To: Prospective Bidders  
From: Wold Architects and Engineers  
Date: July 30, 2014  
Comm. No: 133024

Subject: **Addendum No. 3** for Bidding Documents for the: **Courthouse Renovations Phase I & II**

This addendum forms a part of the Contract Documents dated July 3, 2014. Acknowledge receipt of this Addendum on the space provided on the Bid Form. Failure to do so may result in disqualification of Bid.

### 3. SHEET A3.01 – DOOR & FRAME TYPES AND ELEVATIONS, ENLARGED PLANS

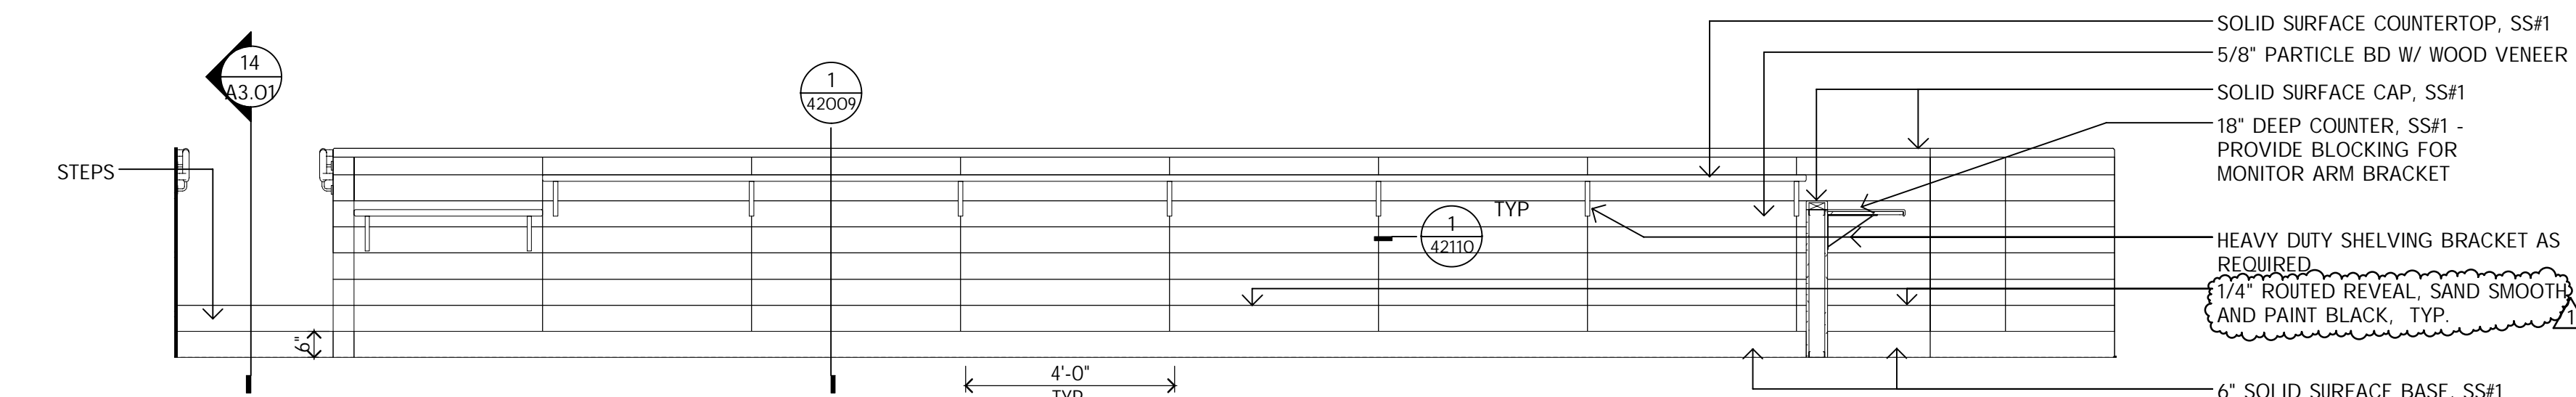
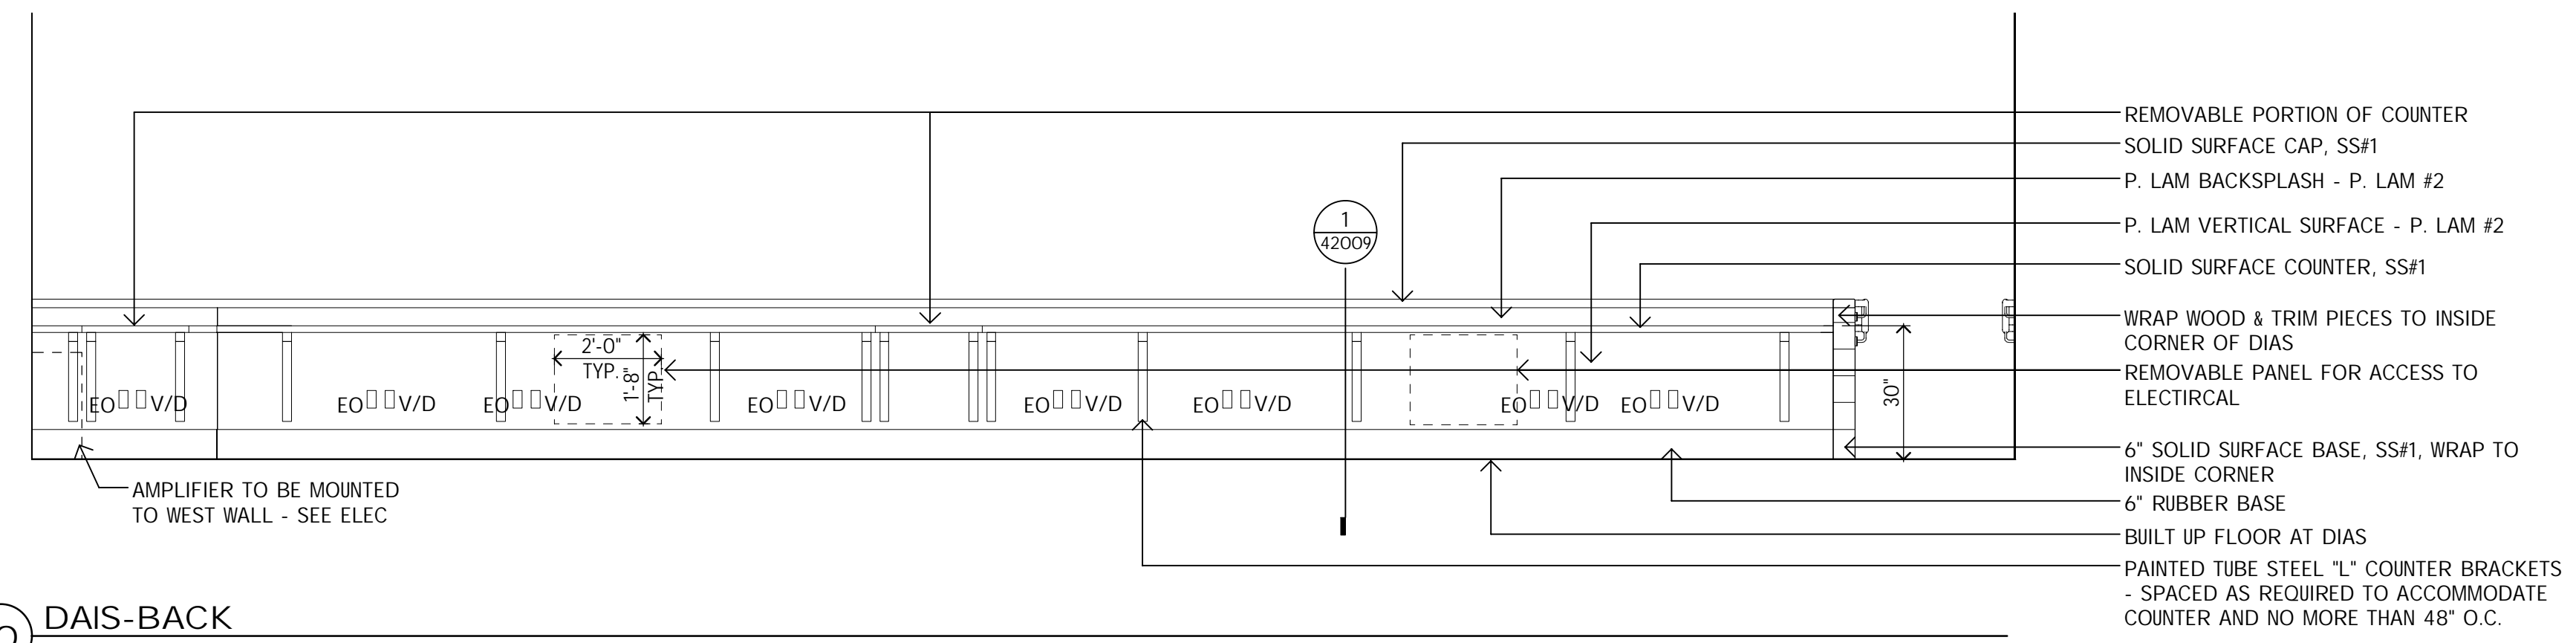
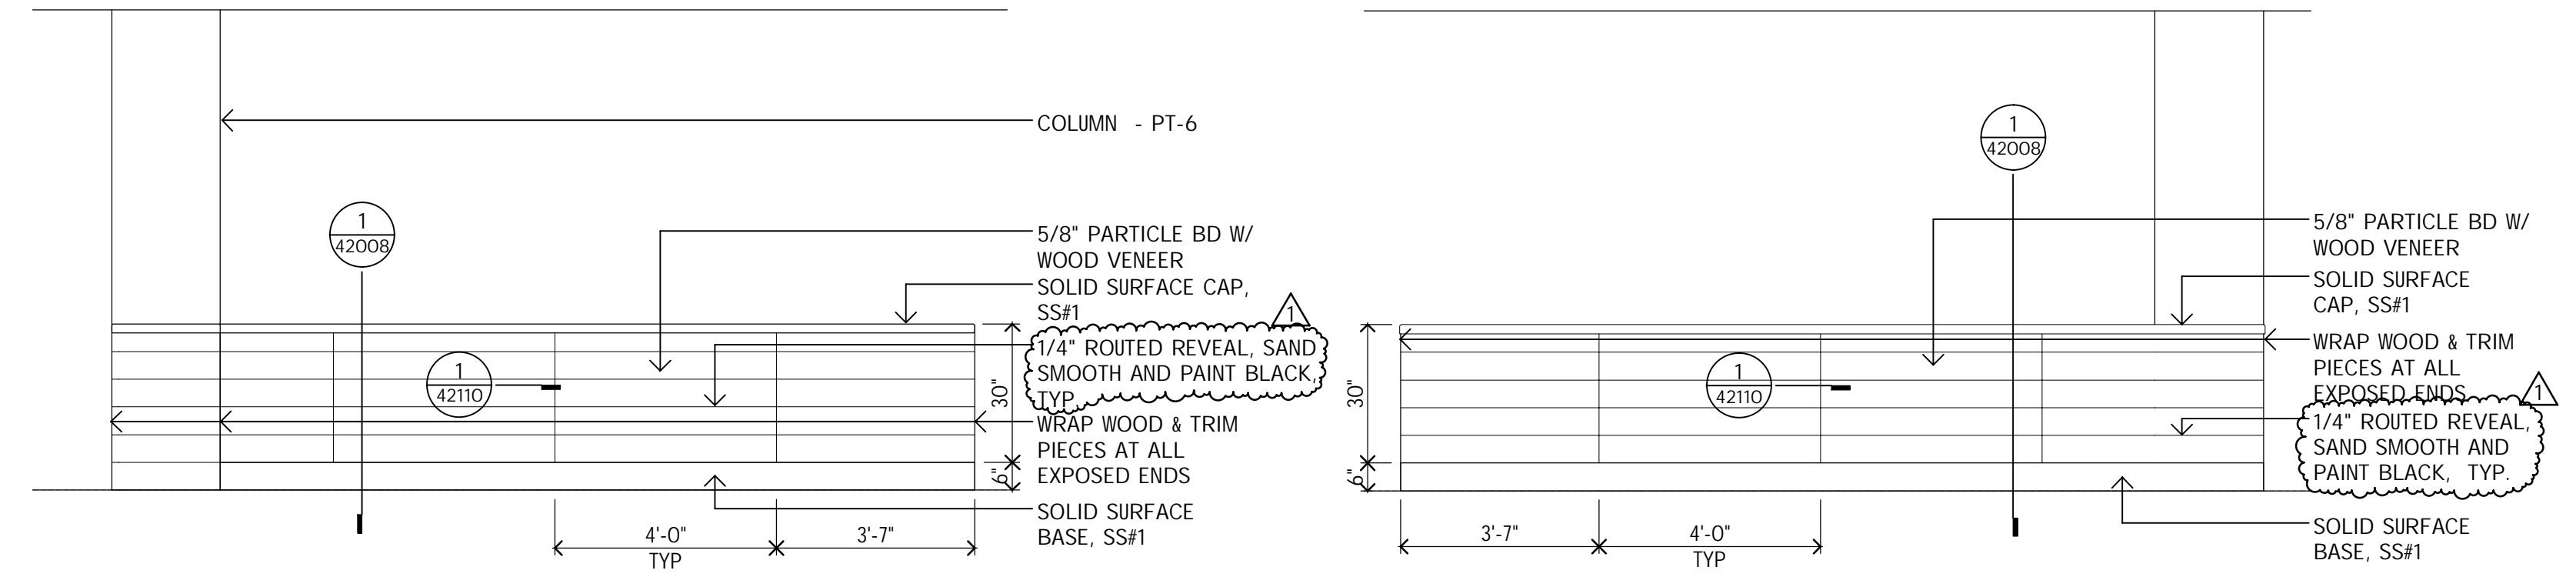
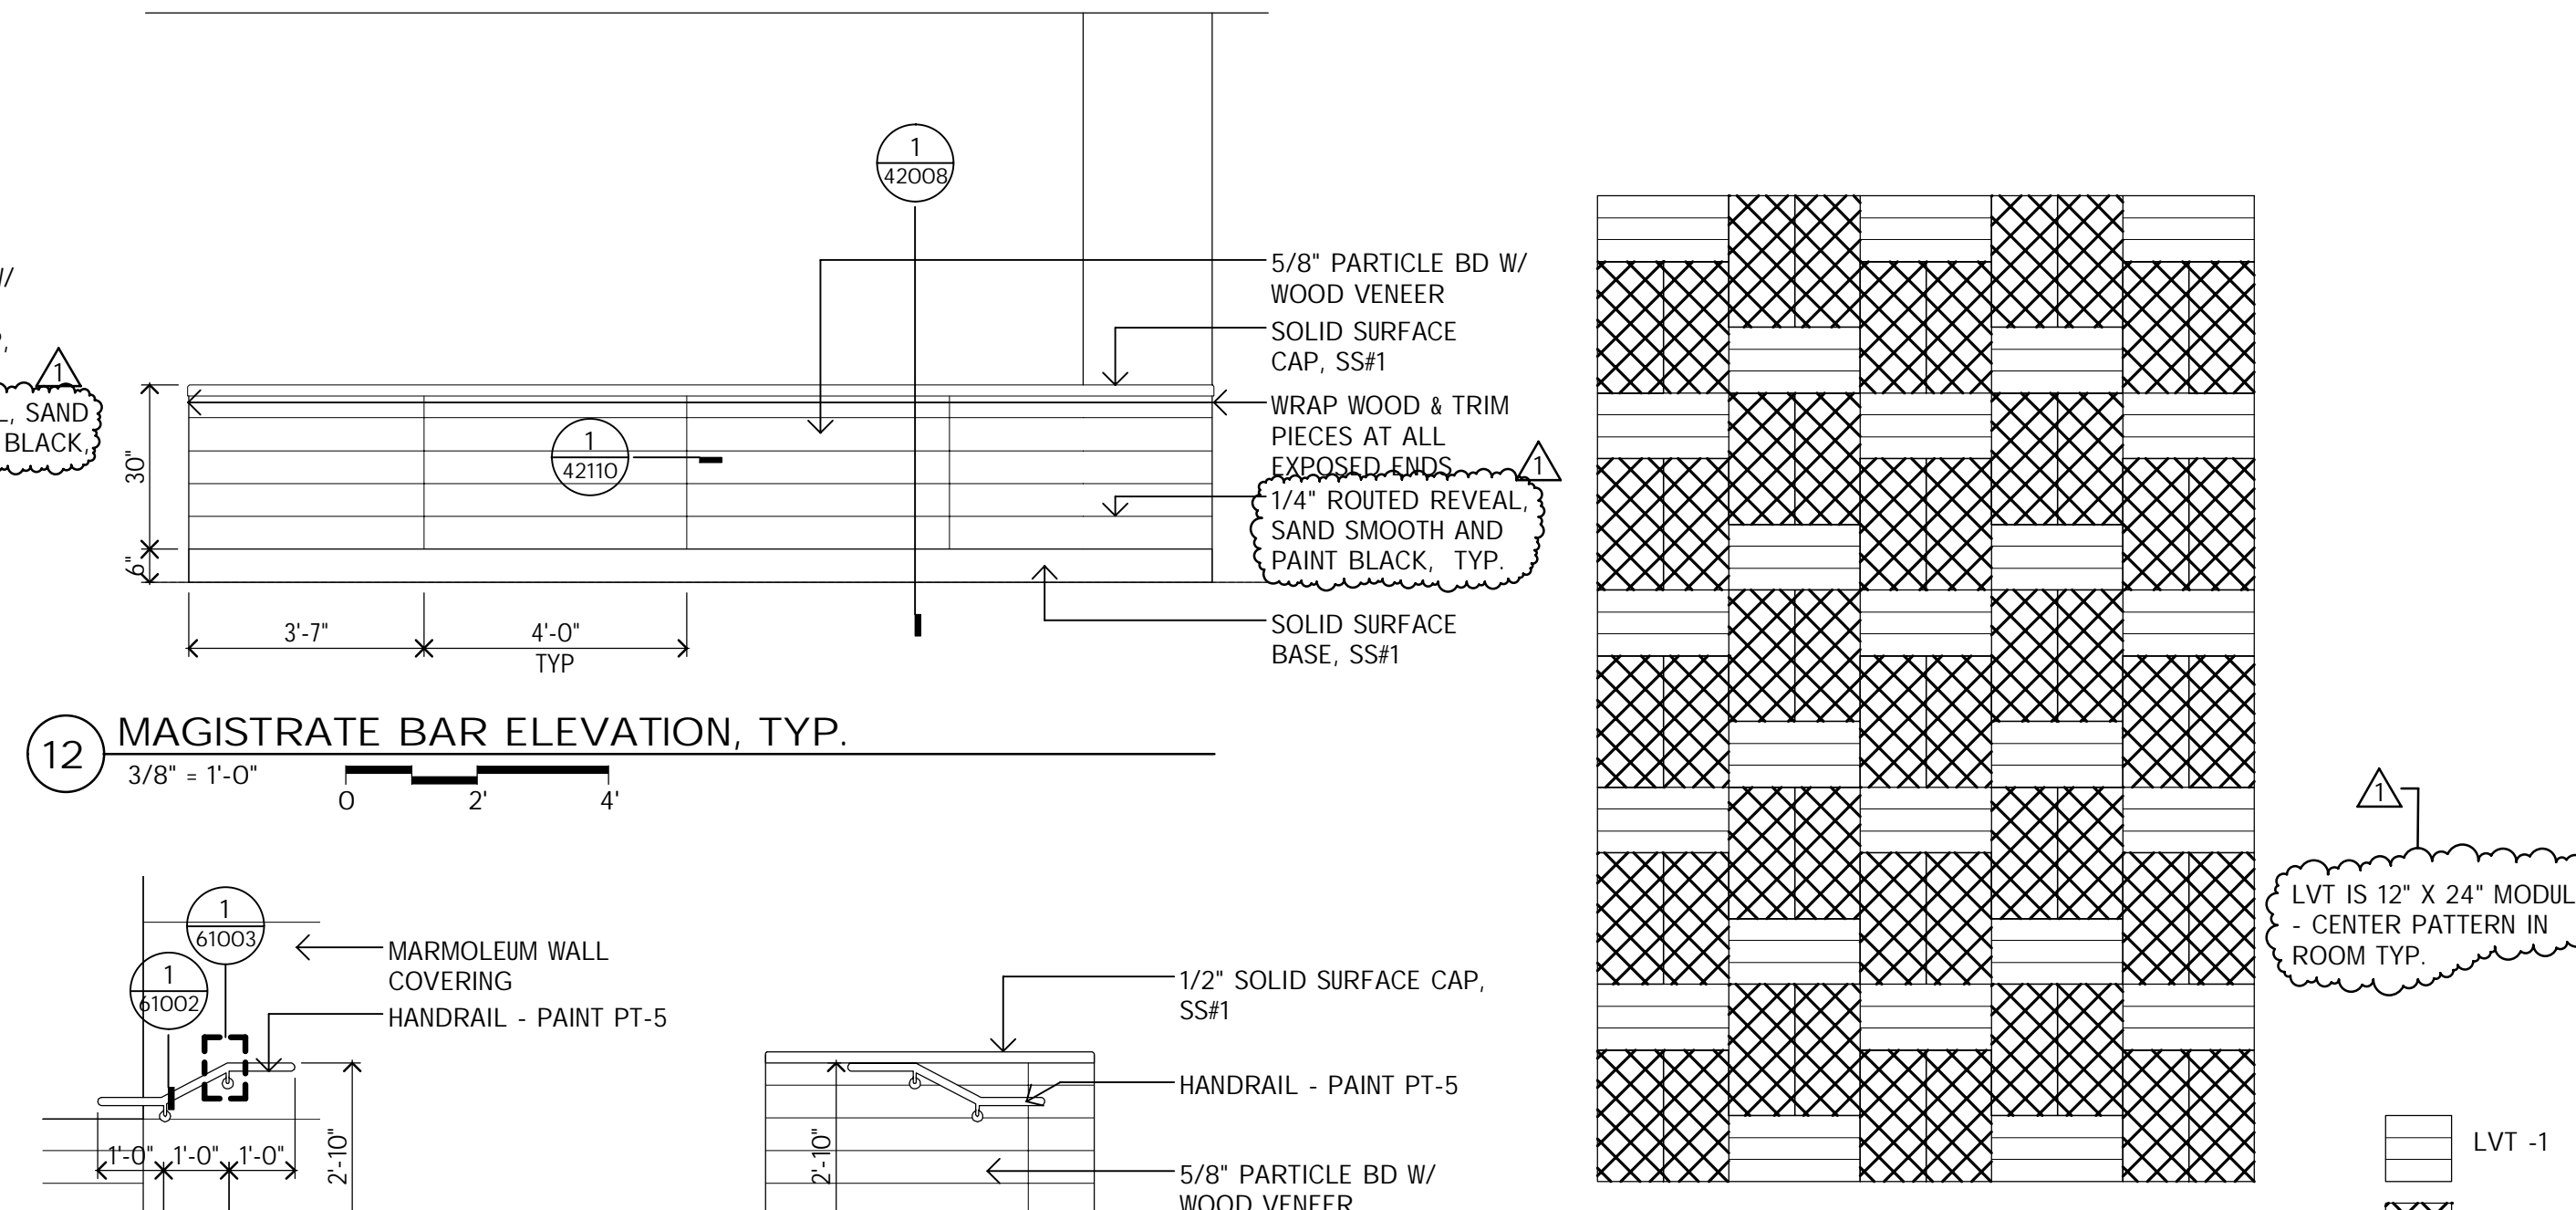
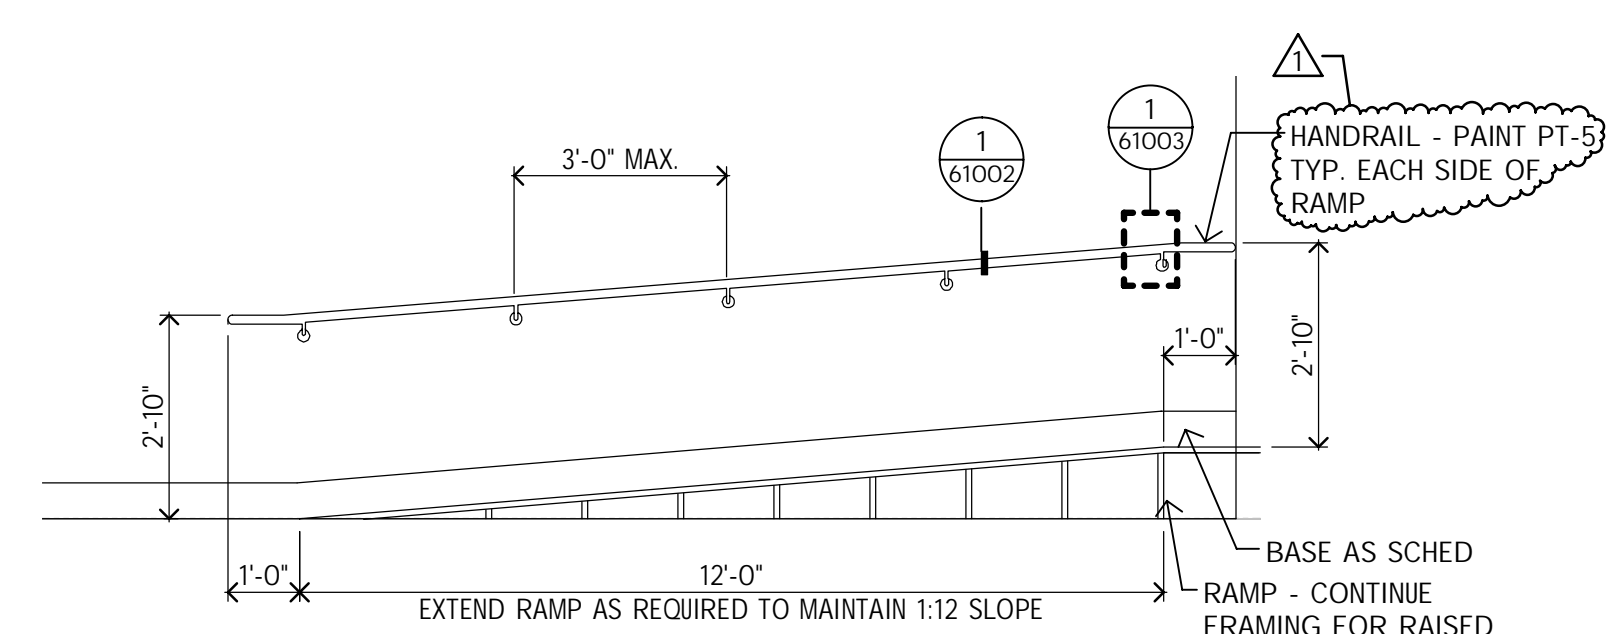
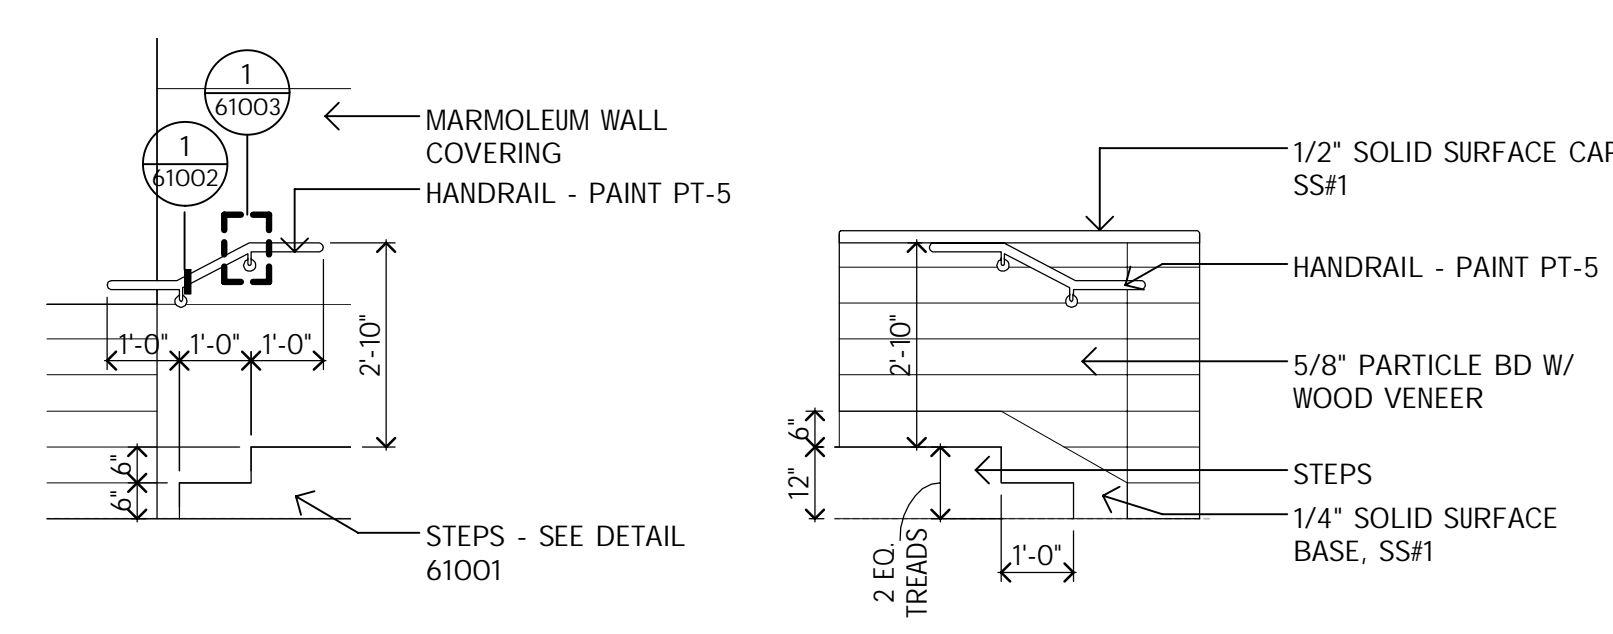
A. Refer to attached Sheet A3.01 for the following revisions;

1. Addition of detail and elevation callouts at casework rail at Enlarged Magistrate Plan 8.
2. Clarification to notes at Ramp Section 13.
3. Clarification to notes at Elevations 9, 11, and 12.
4. Clarification to Floor Pattern 16.
5. Clarifications made to Enlarged Toilet Plan 7.
6. Revision of Tile Pattern Detail 6 title.
